REPORT TO PLANNING COMMISSION

Hearing Date: June 11, 2012
File Number: 2012-7012

SUBJECT: **Steve Hoffman (Appellant) / 162 N Wolfe LLC (Applicant/ Owner)**: Application for a 0.36-acre site located at **162 North Wolfe Road** in an M-S Zoning District (APN: 205-43-027):

Motion **2012-7012 –** Appeal of a decision by the Director of Community Development approving a Miscellaneous Plan Permit for parking lot restriping and minor landscaping modifications.

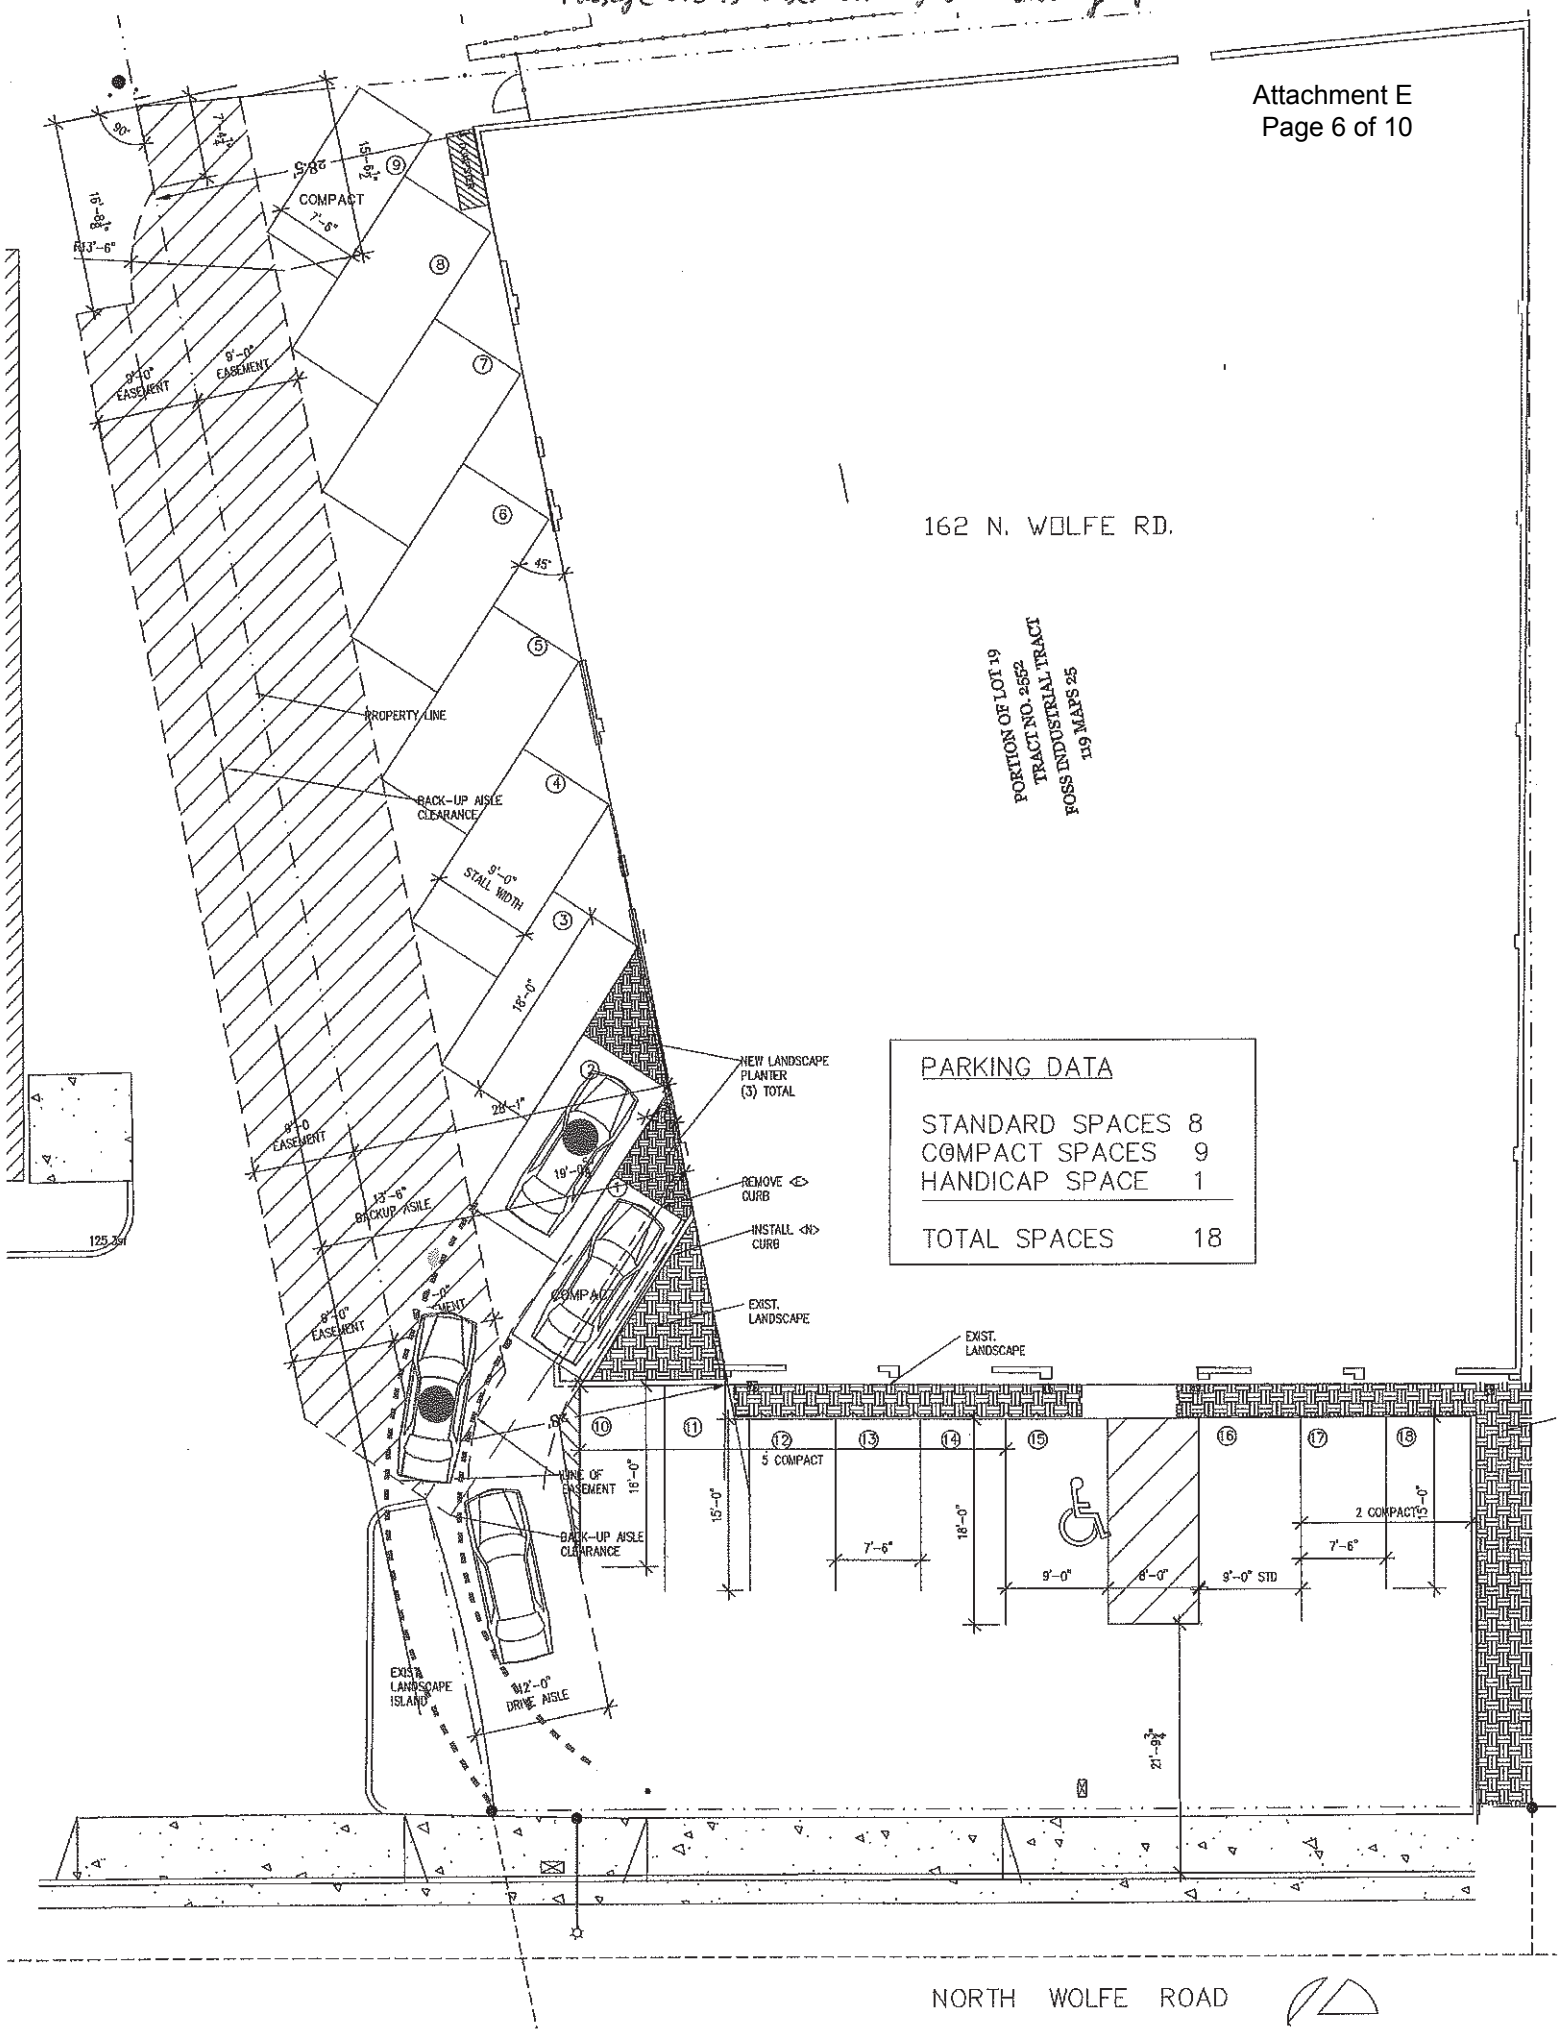
Passage arc is based on my understanding of the code. Steve Hoffman

Staff response: The appellant provides six diagrams depicting a vehicle turning into the angled parking spaces along the north side of the building. These diagrams appear to indicate that a vehicle cannot enter the angled spaces without driving over an existing landscaping area or crossing outside the easement area. The turning radius shown in these diagrams does not match accepted turning templates used by the City's Transportation and Traffic Division. The first four diagrams suggest a vehicle must swing widely to the left before turning into the angled parking spaces. Transportation and Traffic staff has reviewed the diagrams and confirmed the wide arc shown on these plans would not be necessary for a passenger car or truck. The required drive aisle width of 12 feet would be sufficient to allow vehicles to enter the spaces, and the required back-up distance of 13.5 feet would be sufficient to allow vehicles to reverse out of the spaces. Additional maneuvering area should not be needed. The fifth and sixth diagrams depict a vehicle entering the angled parking spaces from the east. As noted in #2 above, vehicles entering from the east could back into the parking spaces. In addition, implementation of the Parking Management Plan will address concerns about these vehicular movements.

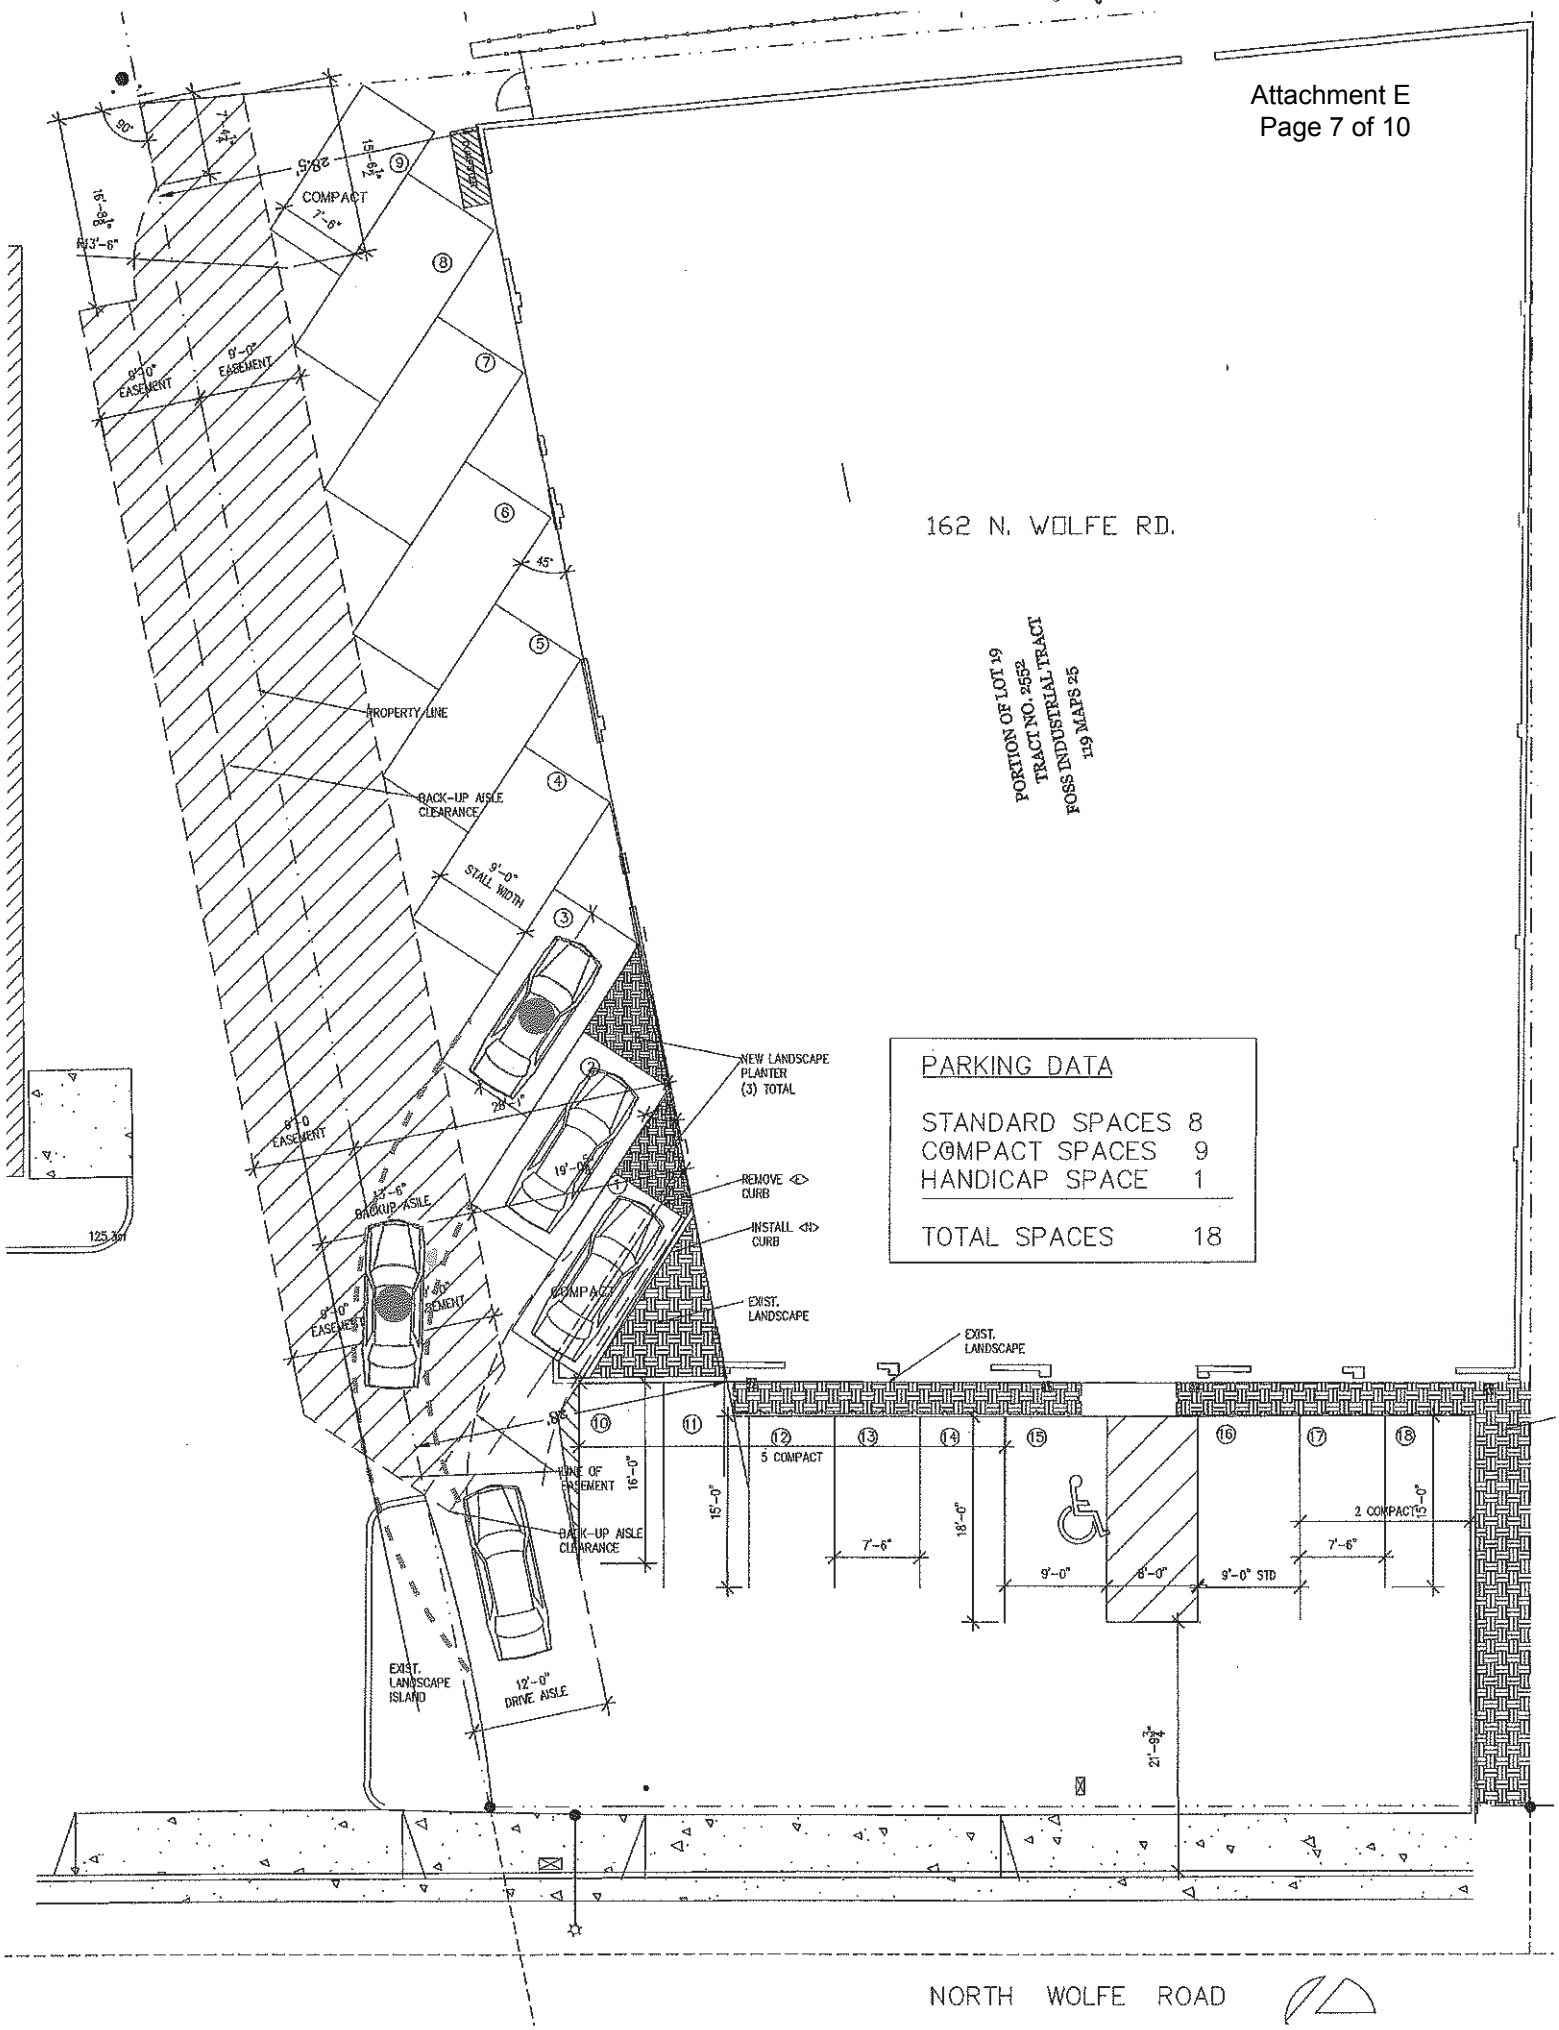
Passage arc is base on my understanding of the code. Steve Hoffman

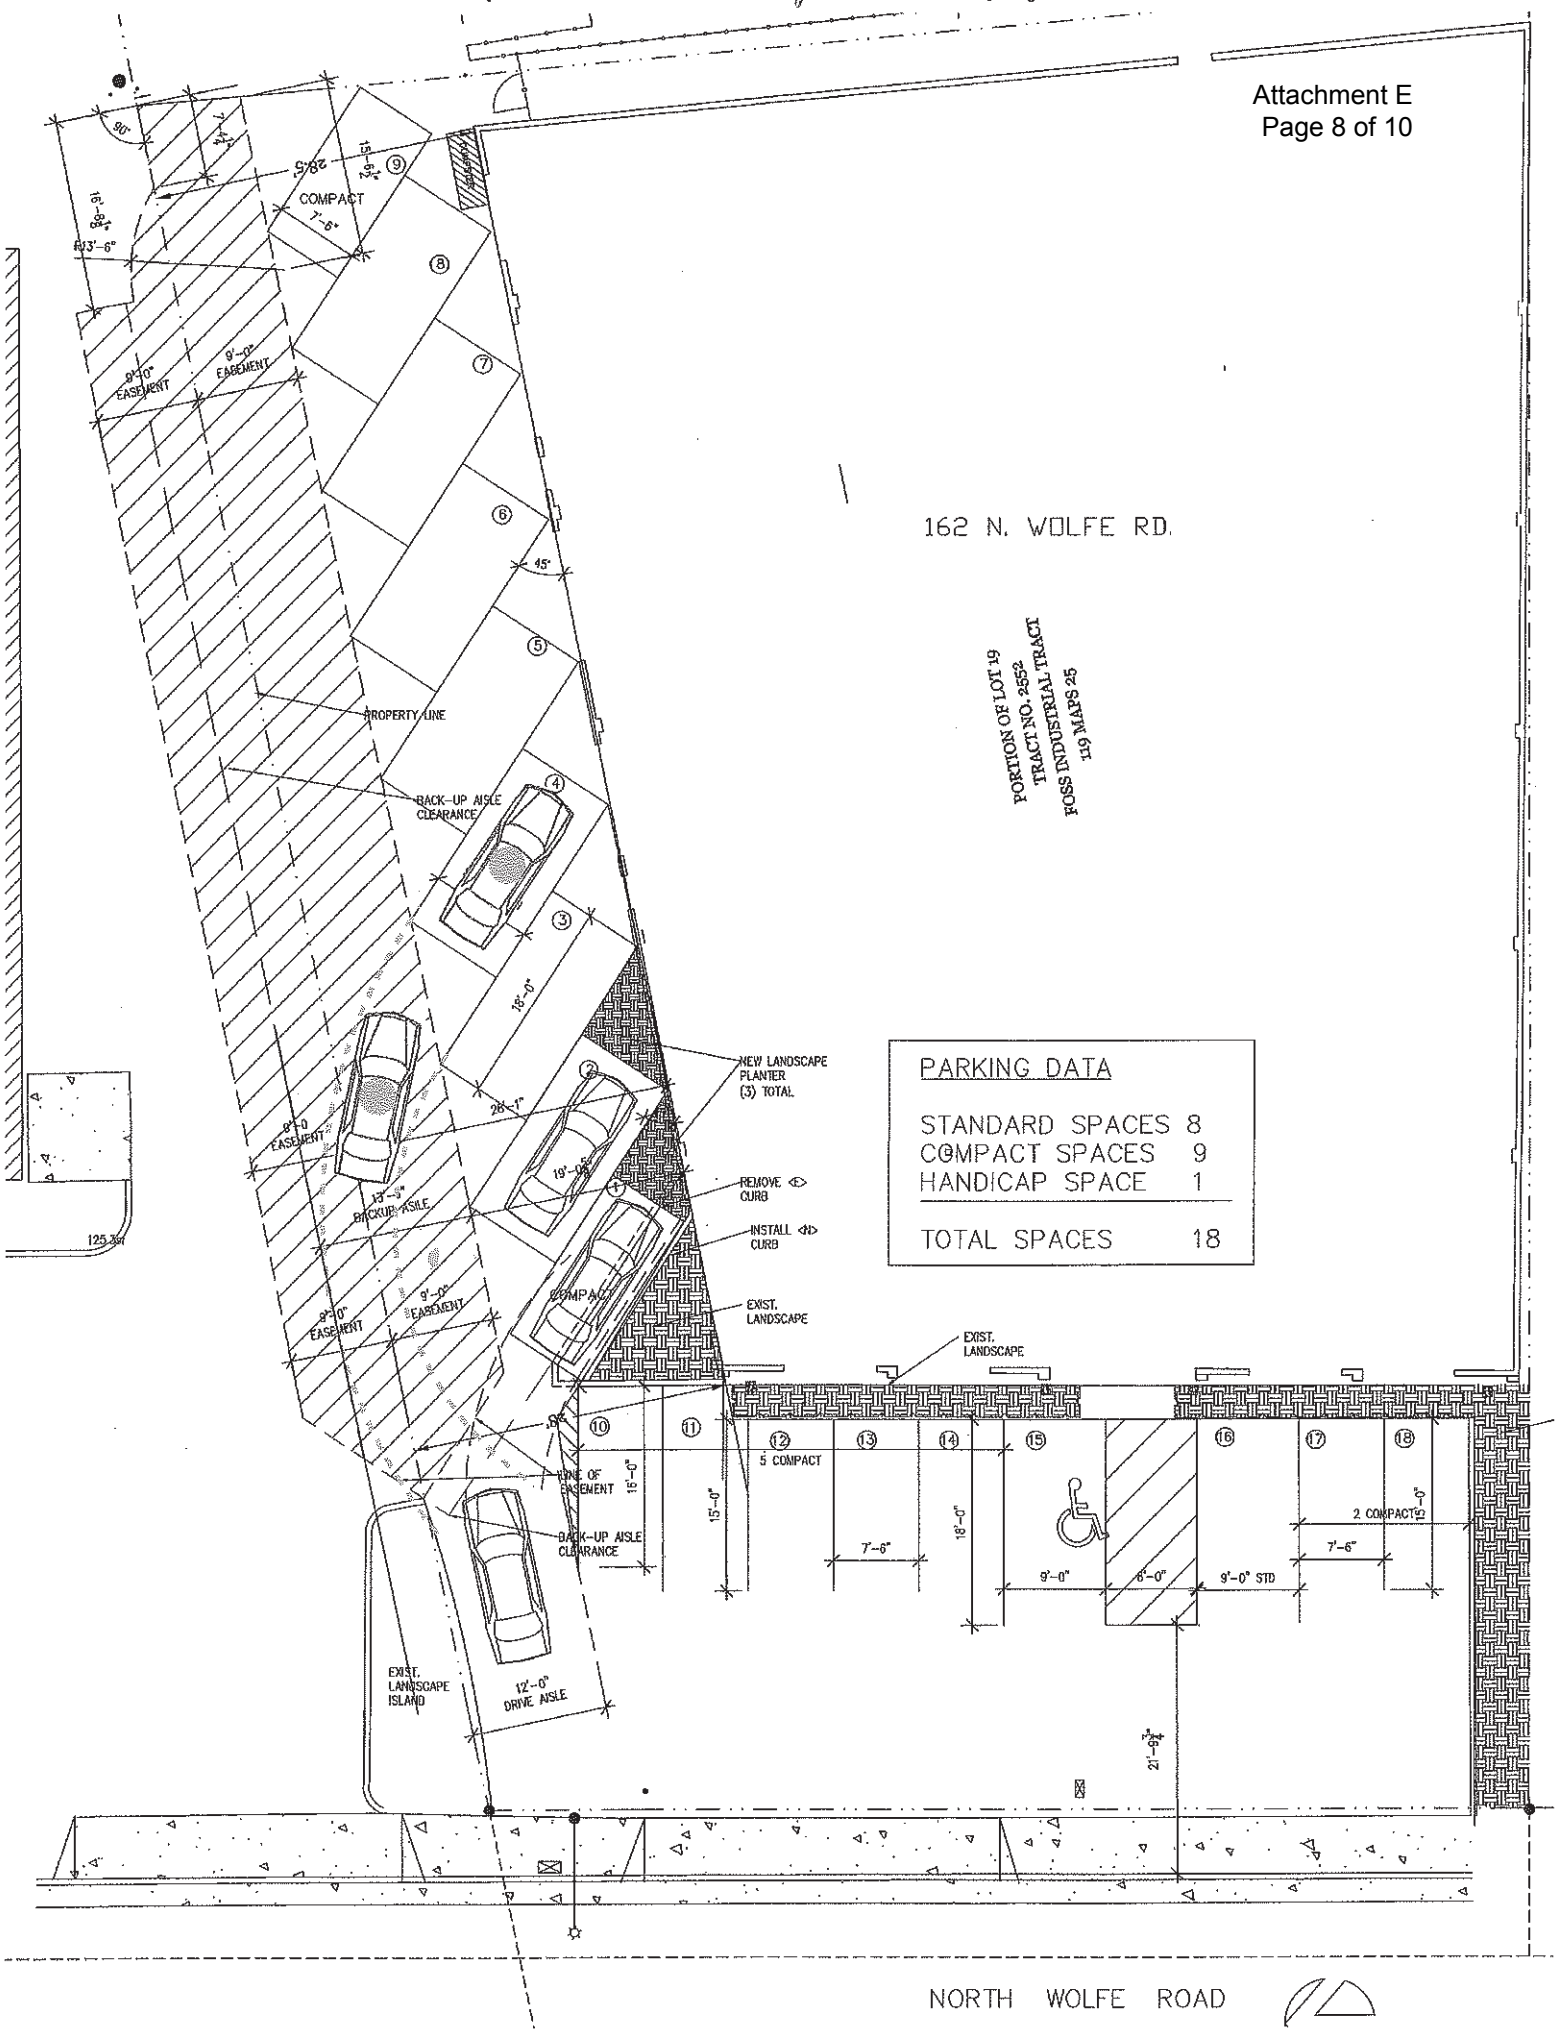
Passage arc is based on my understanding of the code. Steve Hoffman
